Village of Cassopolis

CWSRF Interceptor Force Main Replacement

ADDENDUM 1

June 12, 2026

Sheet SR-0.1 – SESC and Surface Restoration Details and Notes

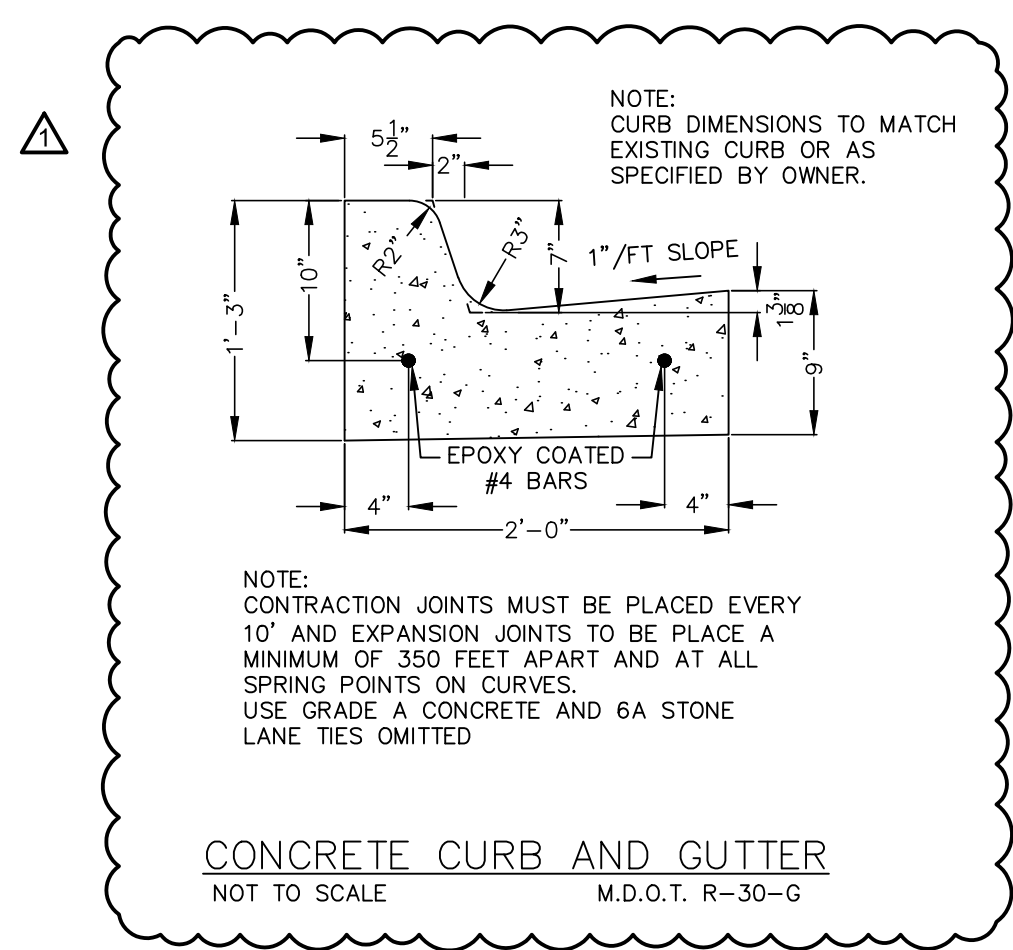
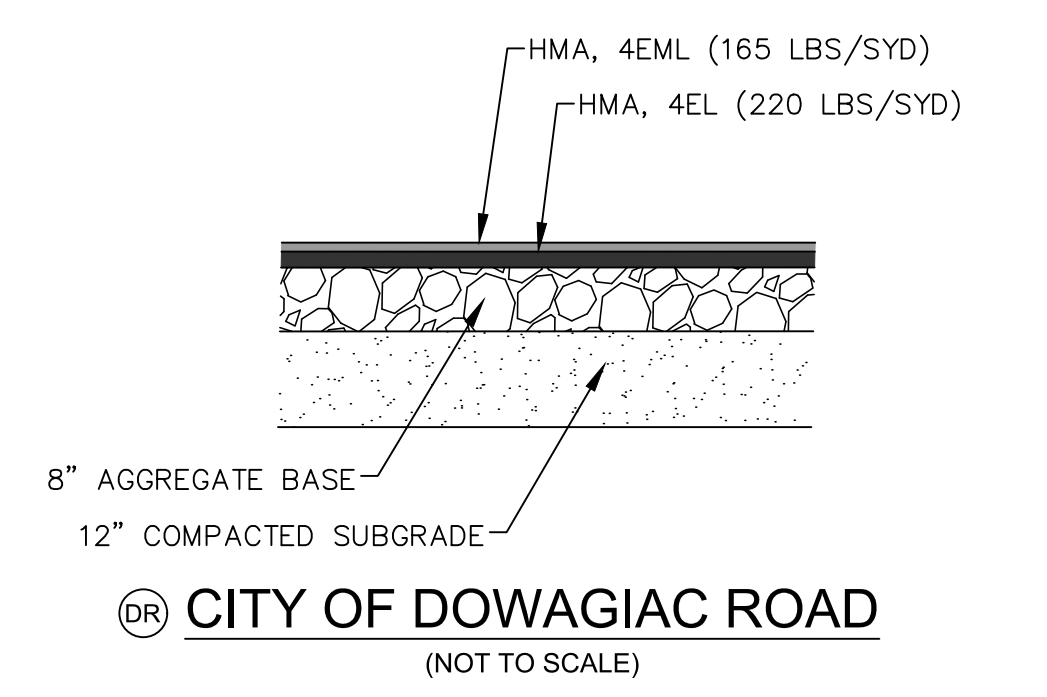
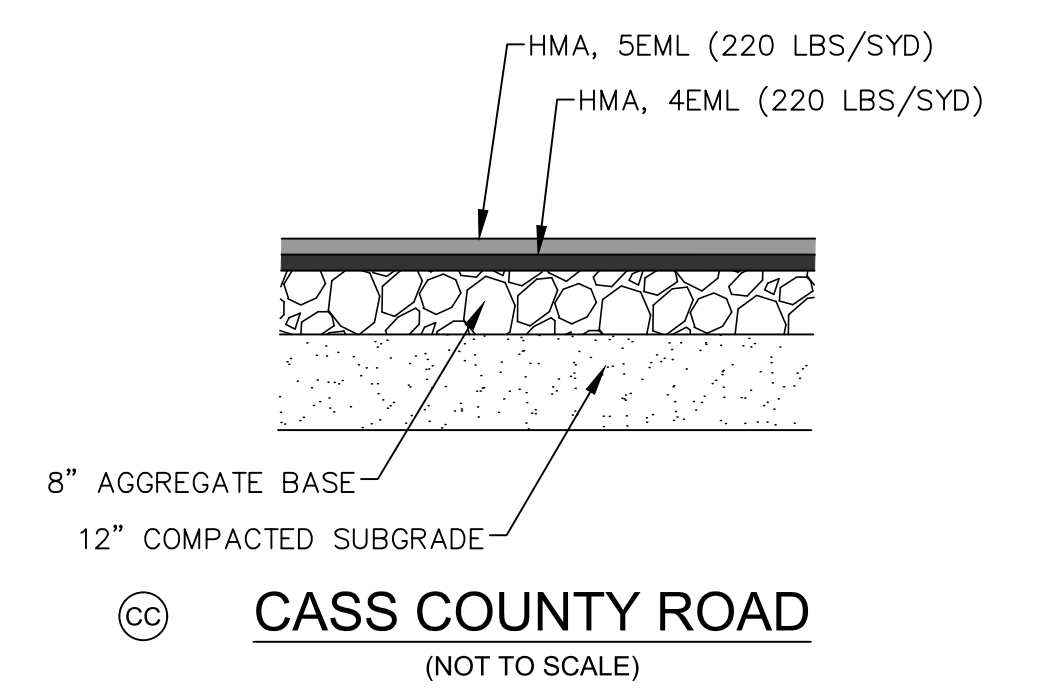
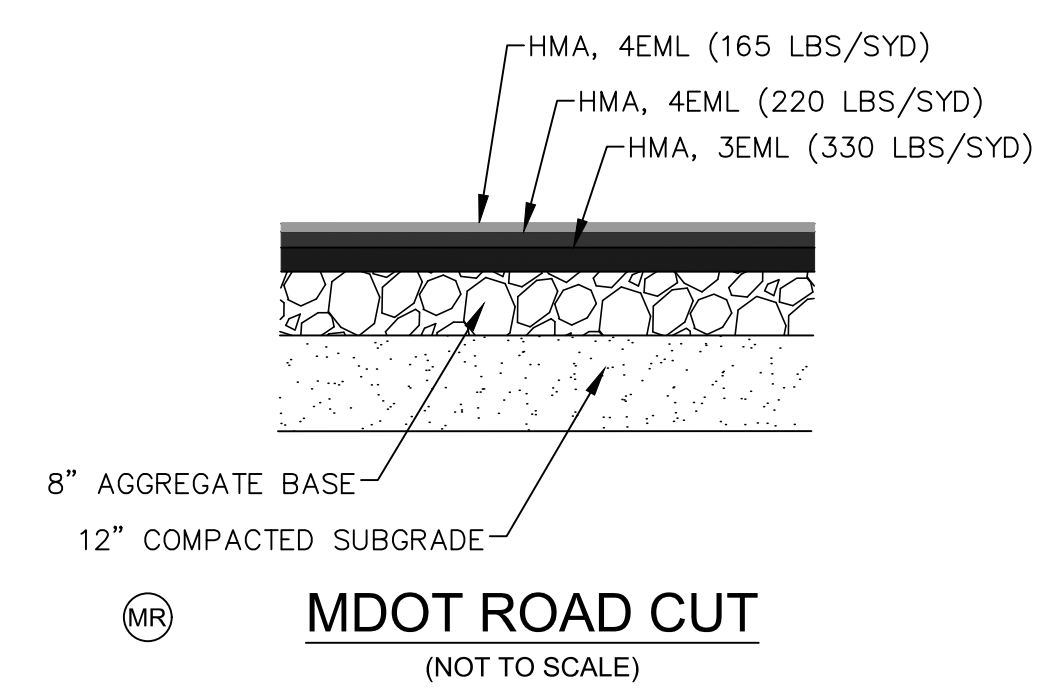
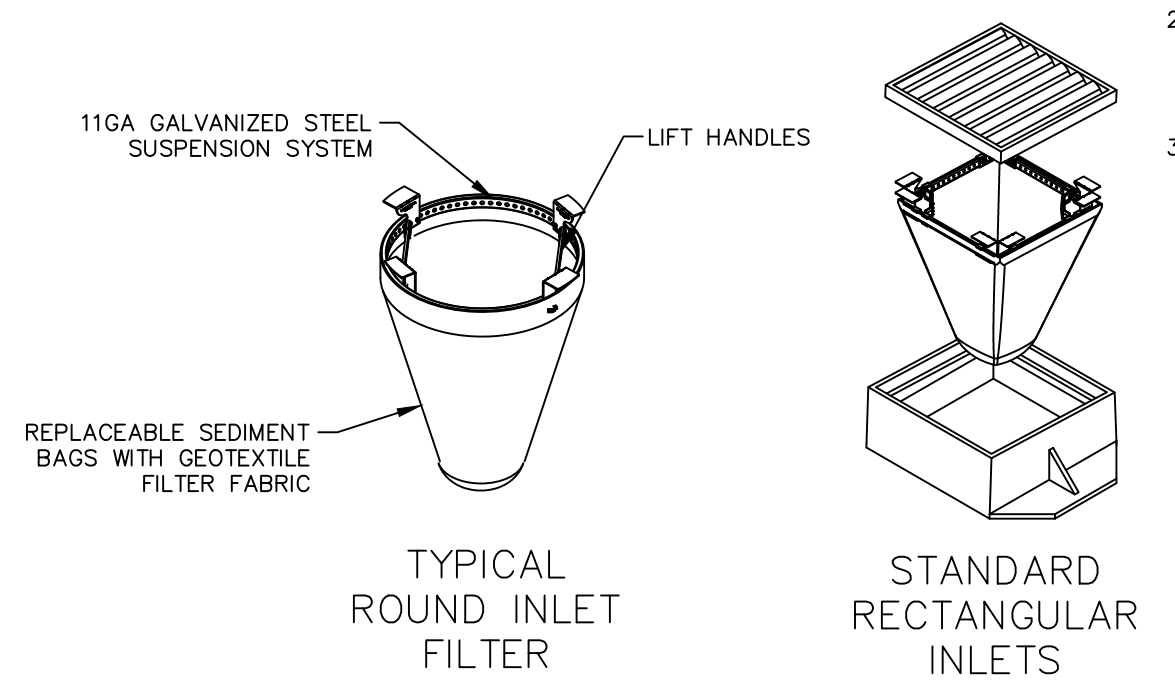
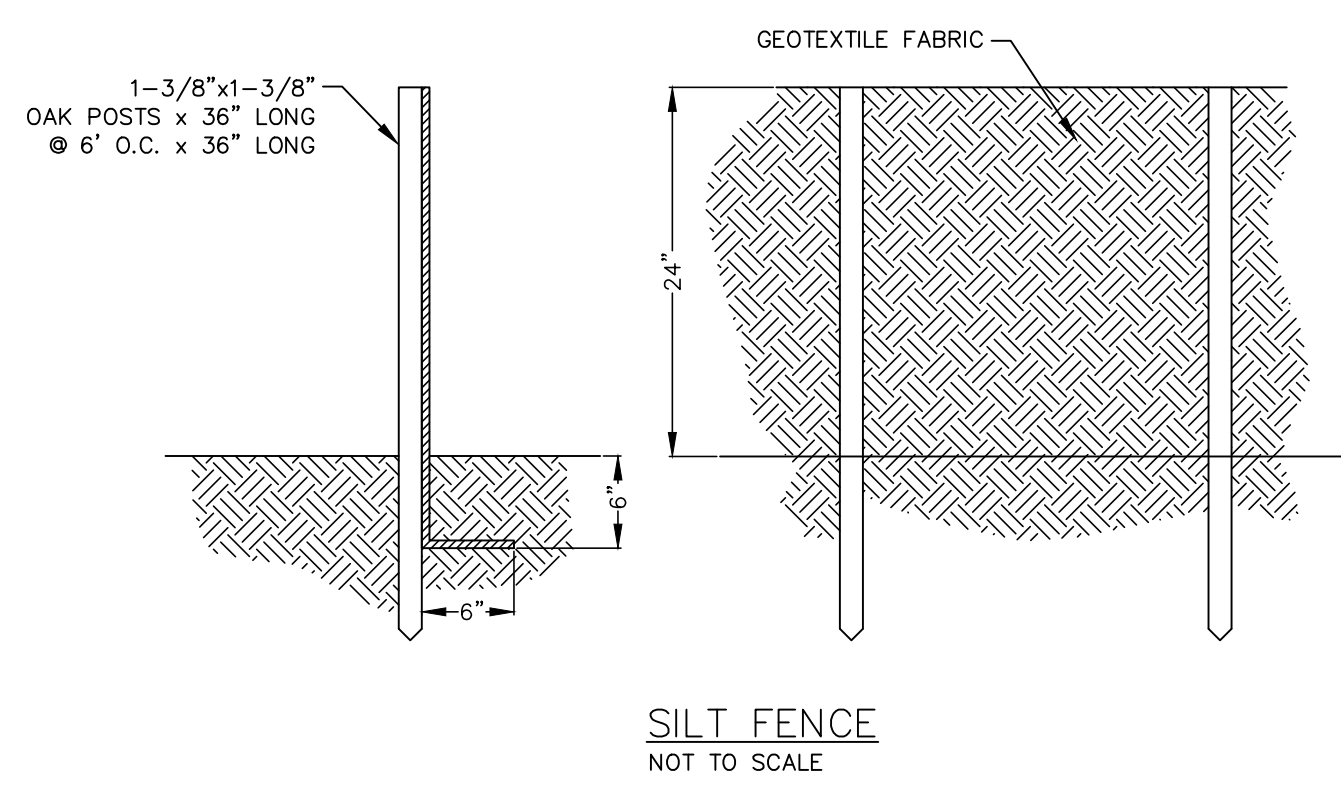
The MDOT Curb and Gutter detail was added to this sheet and the sheet name changed from 75 to SR-0.1. Replace the sheet with the provided Sheet SR-0.1 included with Addendum 1.

NOTE:
1. THE MDOT CURB AND GUTTER DETAIL WAS ADDED TO THIS SHEET AND THE SHEET NAME CHANGED FROM 75 TO SR-0.1. REPLACE THE SHEET WITH THE PROVIDED SHEET SR-0.1 INCLUDED WITH ADDENDUM 1.

Sheet SR-6.3-4 – Peavine Street Surface Restoration Plans Sta. 15+00 to 25+00

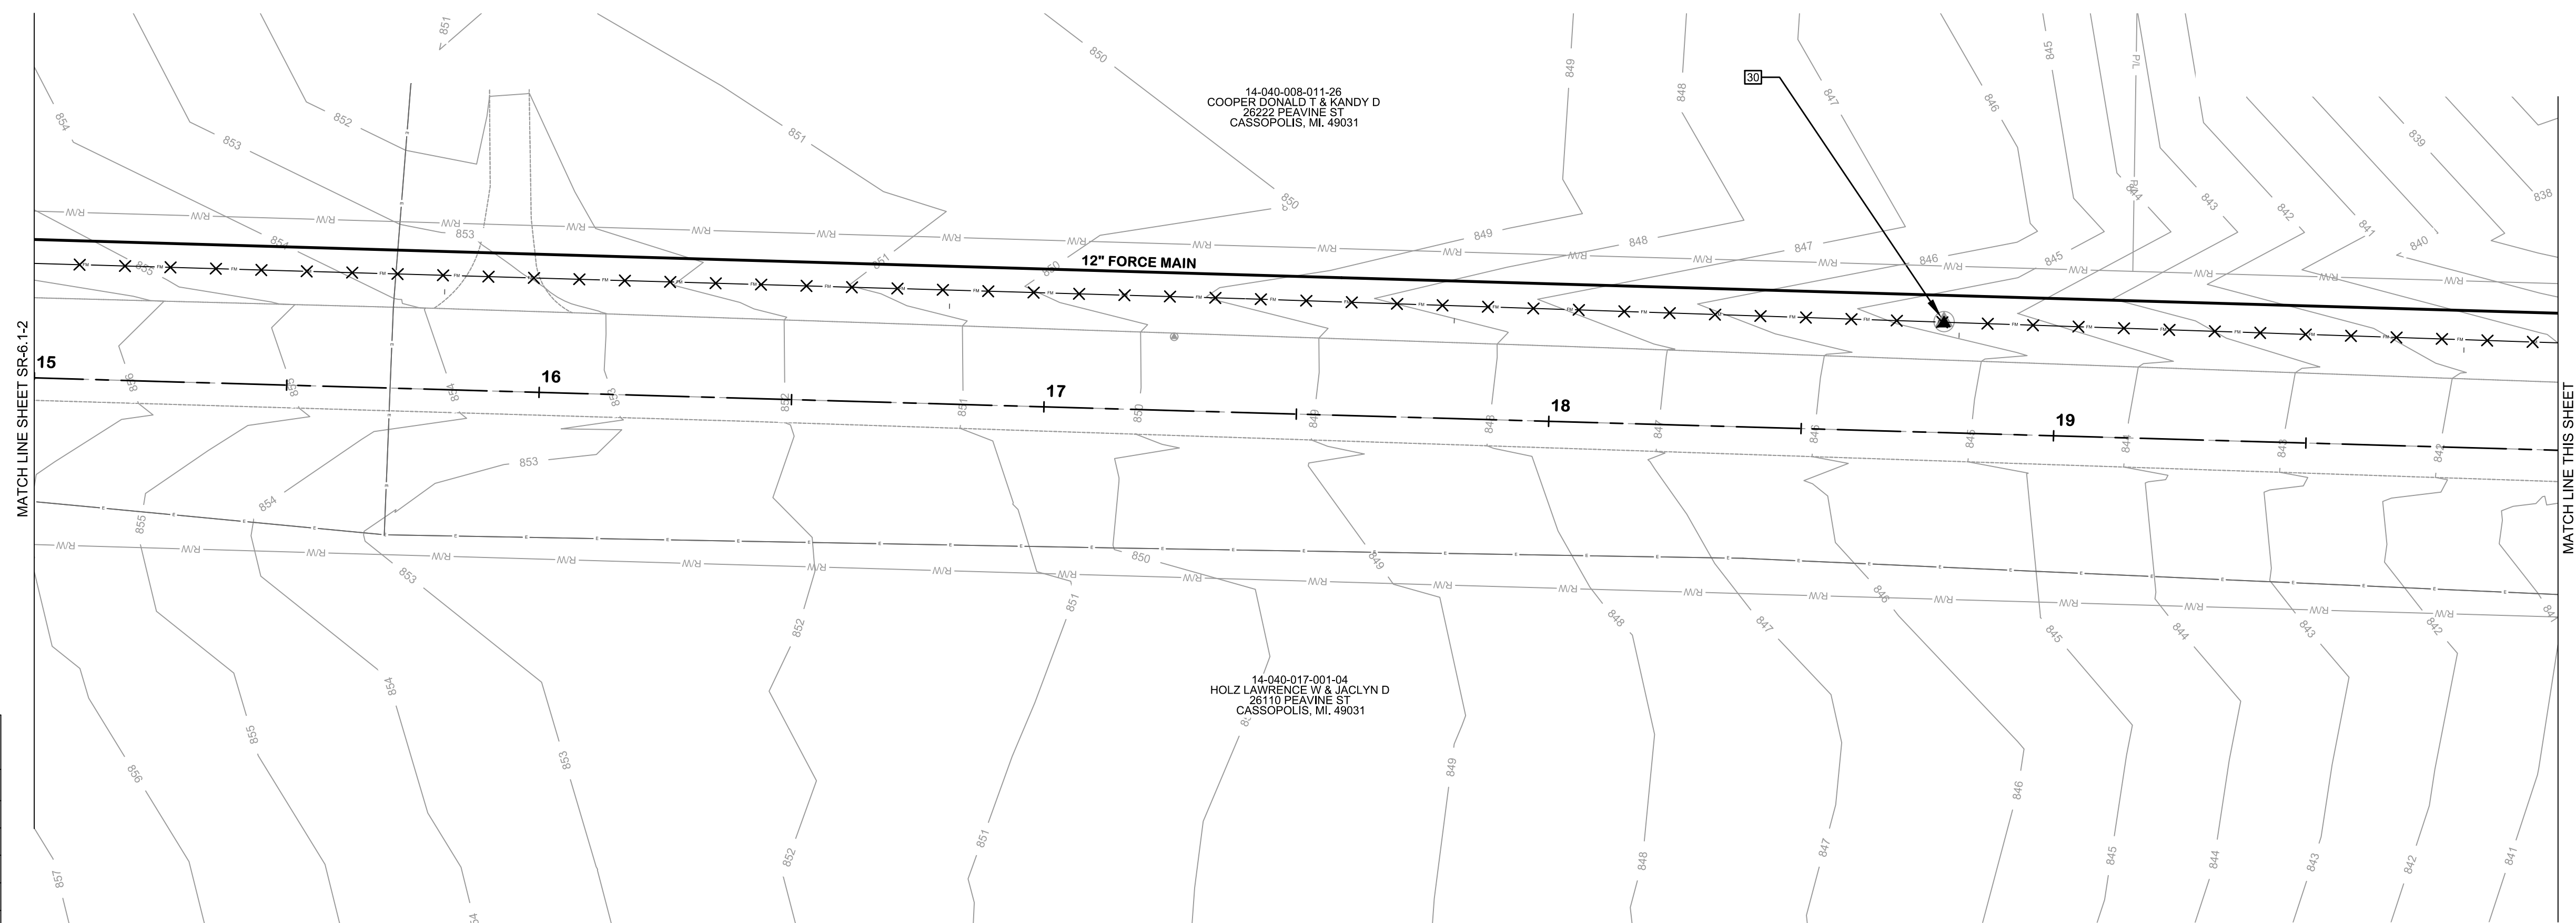
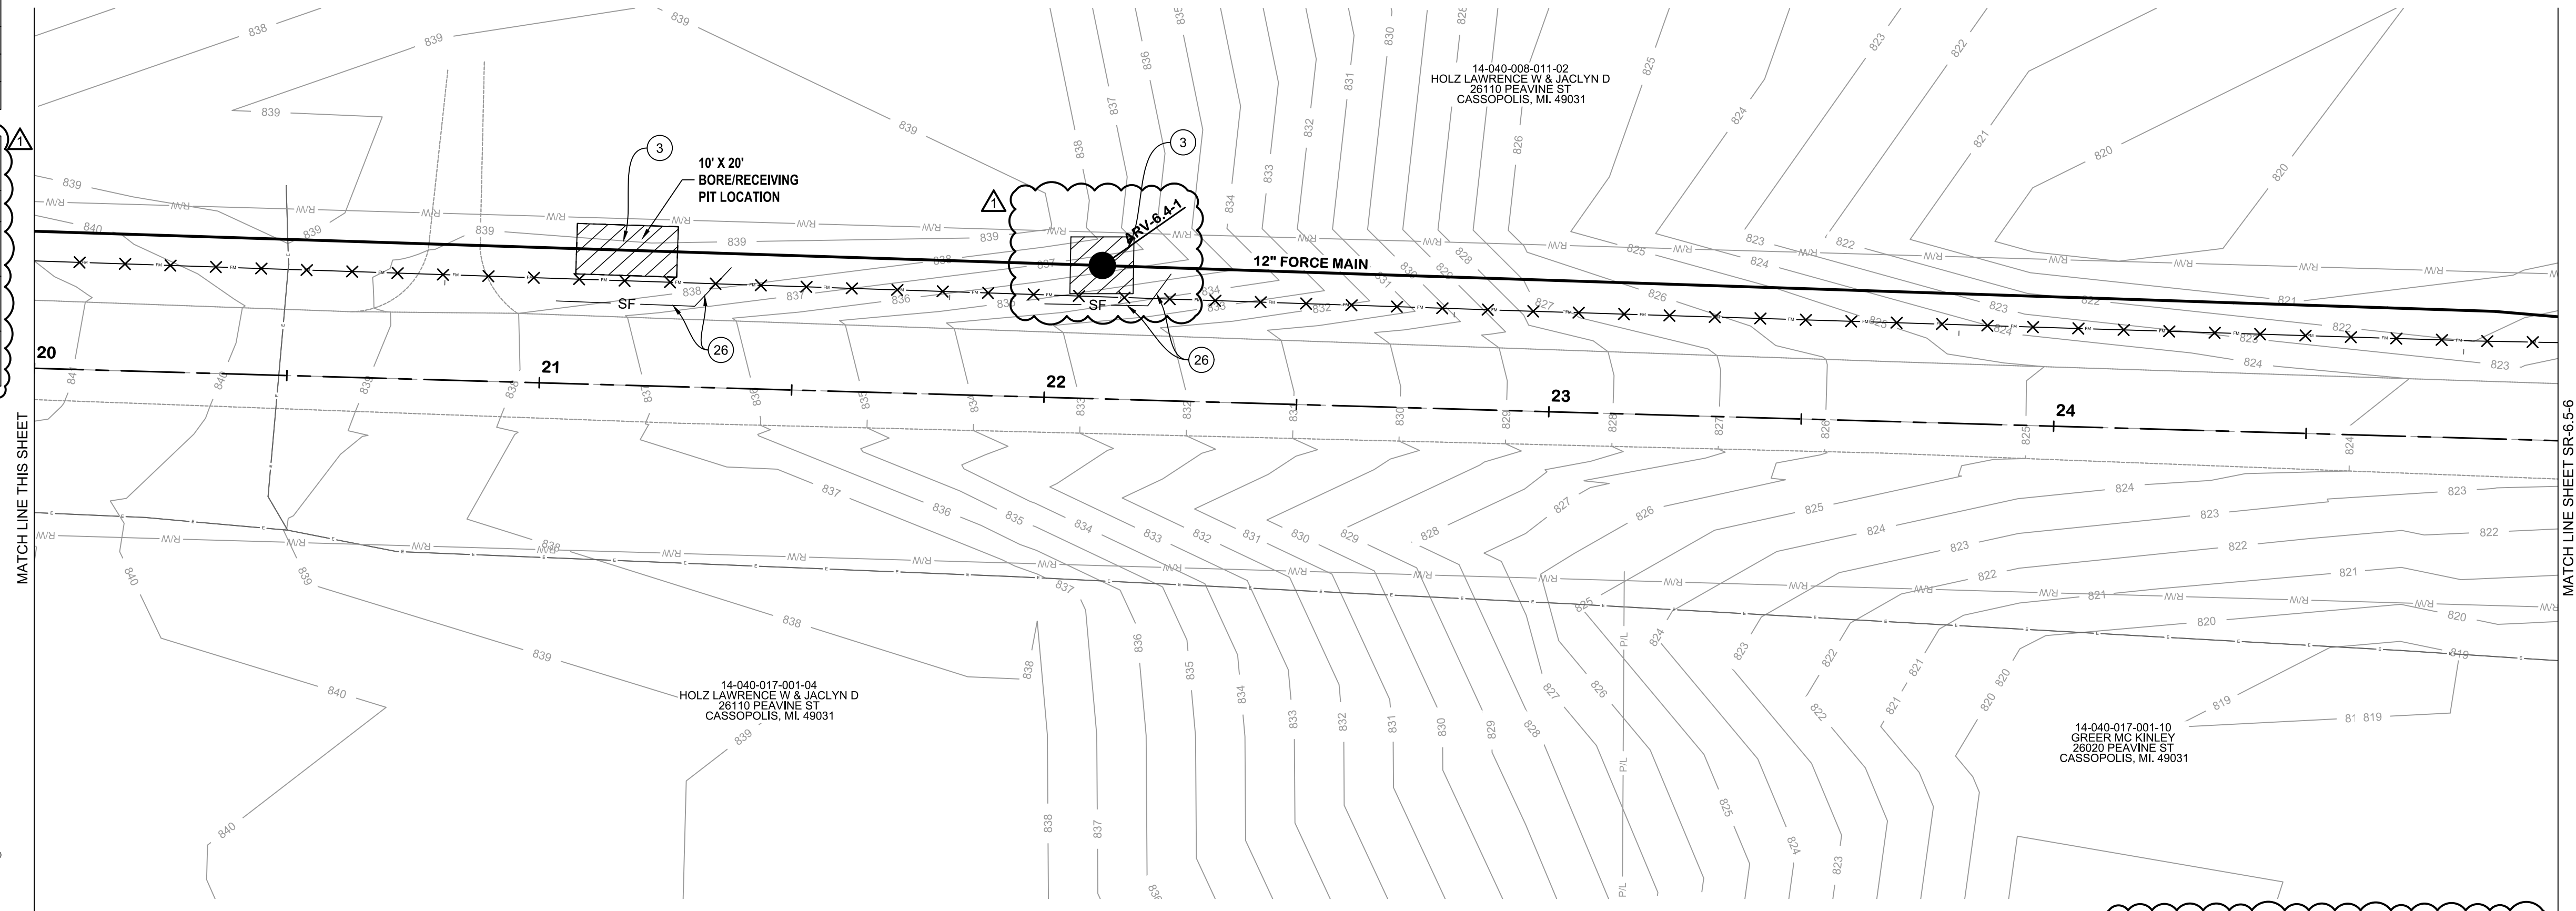
The ARV symbol was modified on this sheet. Replace the sheet with the provided Sheet SR-6.3-4 included with Addendum 1.

NOTE:
1. THE ARV SYMBOL WAS MODIFIED ON THIS SHEET, ALSO, FORCEMAIN LINETYPE AND SURFACE RESTORATION HATCH LEGEND. REPLACE THE SHEET WITH THE PROVIDED SR-6.3.4 INCLUDED WITH ADDENDUM 1.
